**SUNDRY NOTICES AND REPORTS ON WELLS**  
*Do not use this form for proposals to drill or to re-enter an abandoned well. Use Form 3160-3 (APD) for such proposals.*

8. Well Name and No.  
**Big Eddy Unit 248H**

9. API Well No.  
**30-015-40714**

**BOPCO,L.P. is requesting approval to amend point 4 Pressure Control Equipment in the original APD as attached.**

**Latshaw 13-5/8" X 3-M BOPE (2 Rams and Rotating Head) & Closed Loop System Equipment Schematic Diagram 2**

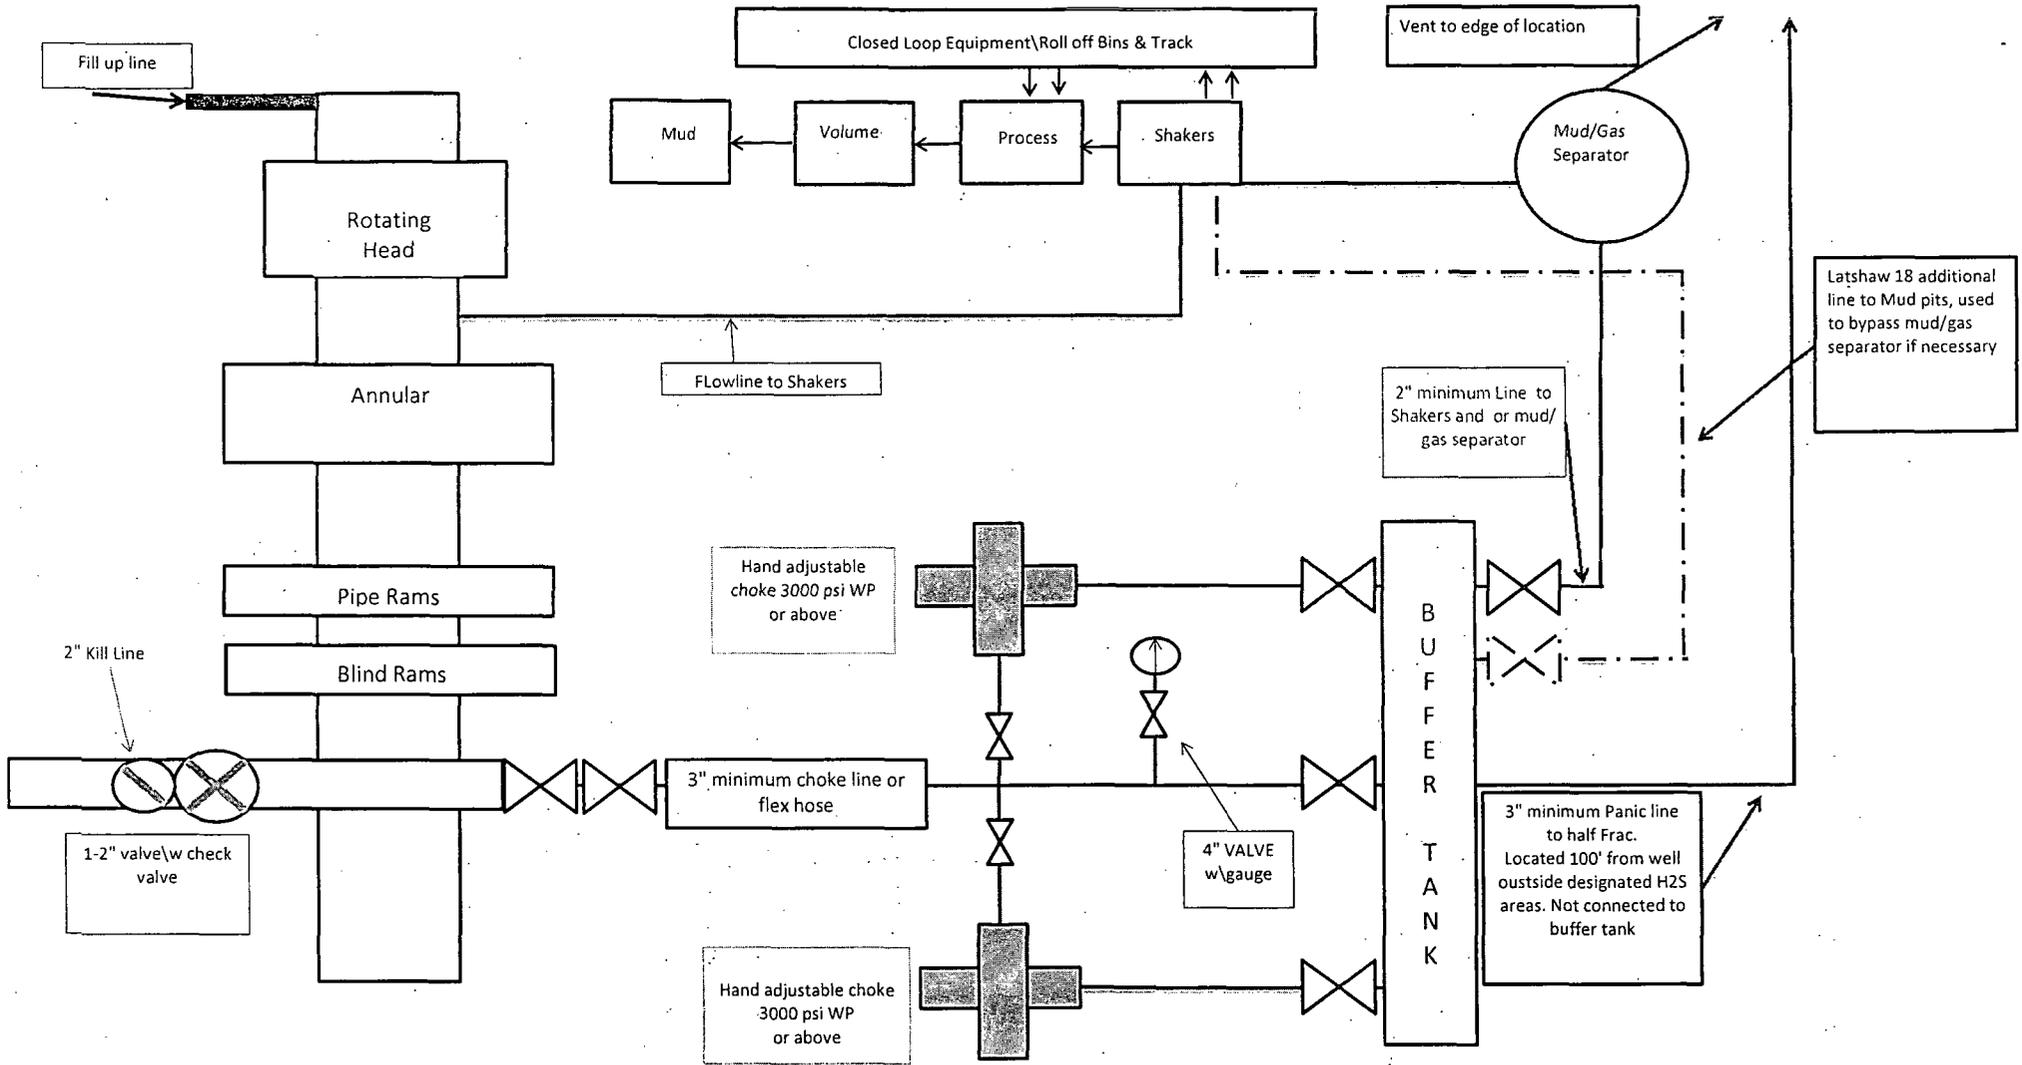
#### **POINT 4: PRESSURE CONTROL EQUIPMENT (SEE ATTACHED DIAGRAM 2)**

After running the 13-3/8" surface casing, a 13-5/8" BOP/BOPE system with a minimum rating of 3M will be installed, used, maintained and tested as per Onshore Order 2. In addition to the high pressure test, a low pressure (250-300 psig) test will be performed.

After running the 9-5/8" intermediate casing, a 13-5/8" or 11" BOP/BOPE system with a minimum rating of 3M will be installed on the 9-5/8" intermediate casing spool (8-3/4" open hole), used, maintained and tested as per Onshore Order 2. In addition to the high pressure test, a low pressure (250-300 psig) test will be performed.

After running the 7" intermediate casing, a 13-5/8" or 11" BOP/BOPE system with a minimum rating of 3M will be installed on the 9-5/8" intermediate casing spool (8-3/4" open hole), used, maintained and tested as per Onshore Order 2. In addition to the high pressure test, a low pressure (250-300 psig) test will be performed.

**13-5/8" X 3-M BOPE (2 Rams and Rotating Head) & Closed Loop System Equipment Schematic H2S contingency Diagram 2**

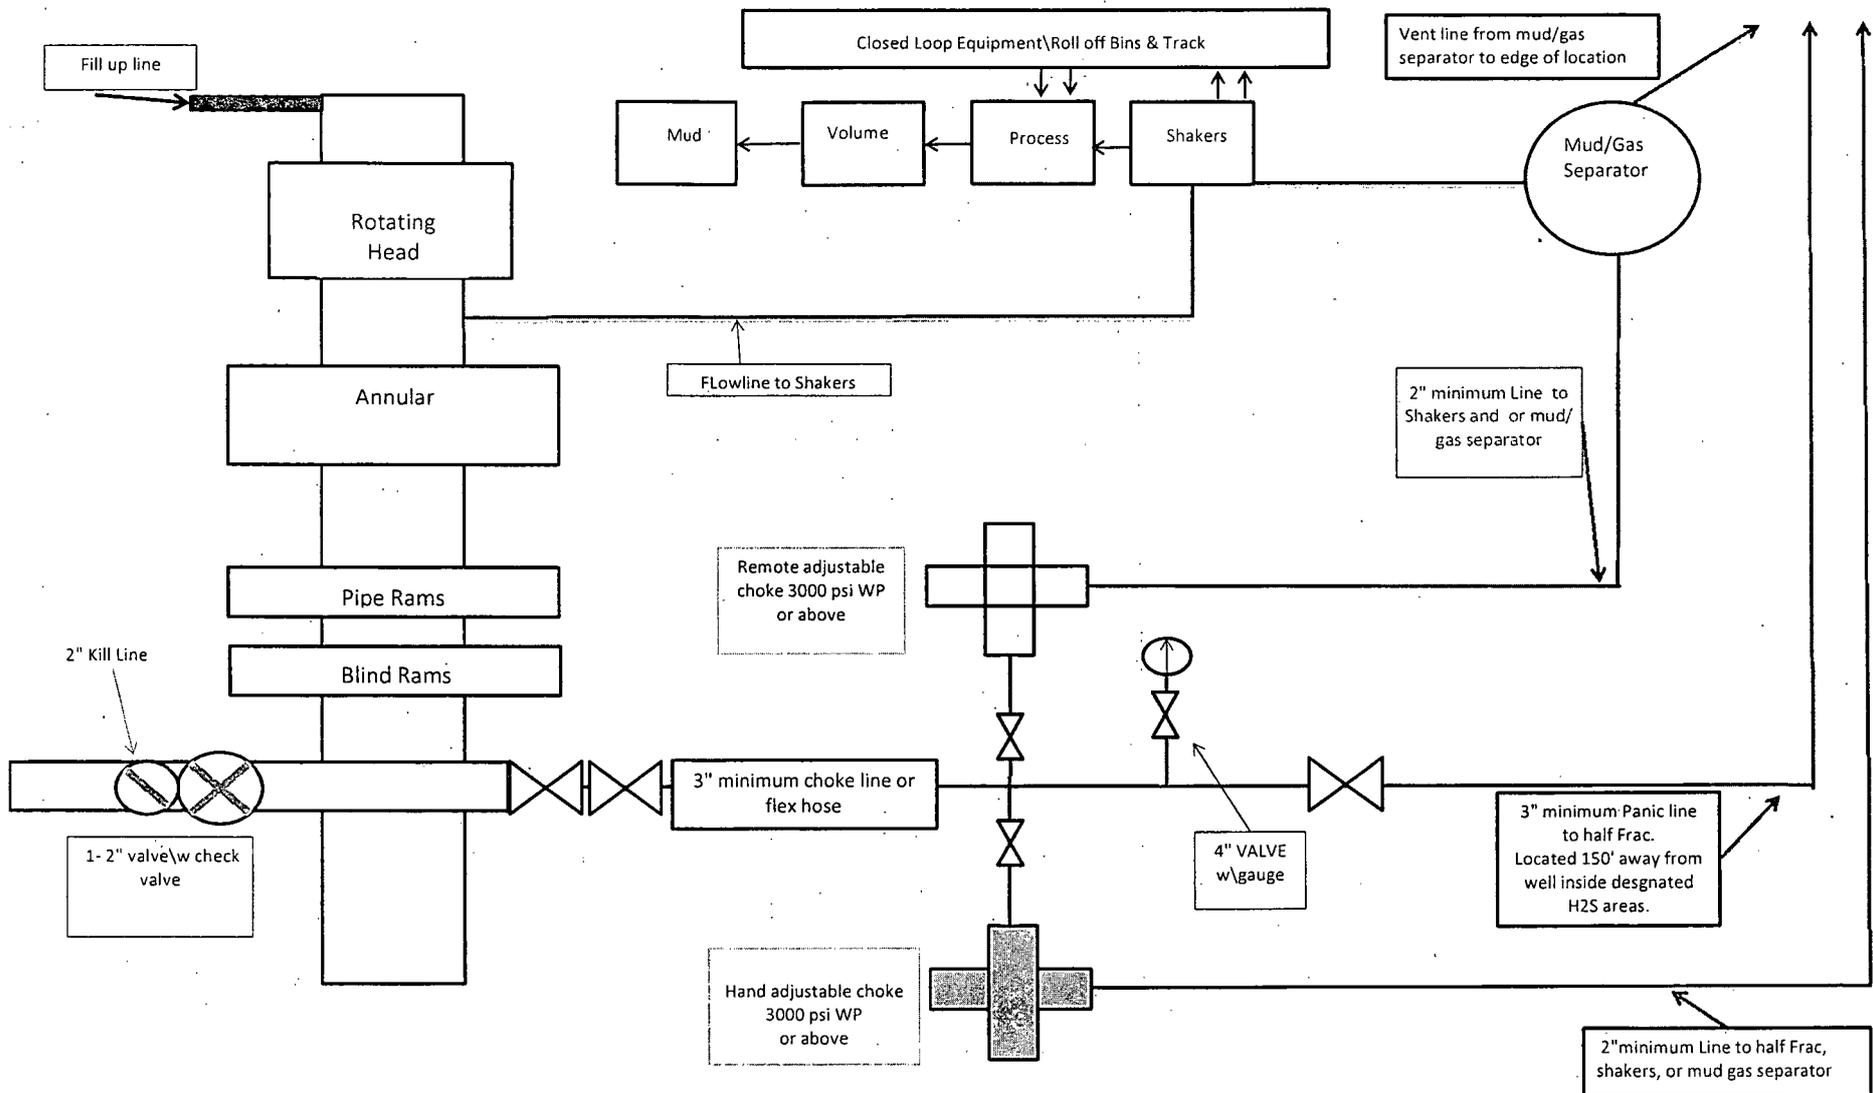
#### **H2S contingency**

H2S monitors shall be installed prior to drilling out the surface shoe. If H2S is encountered in quantities greater than 10 PPM, the well will be shut in and H2S equipment will be installed, including a flare line that will be extended pursuant to onshore oil and gas order #6.
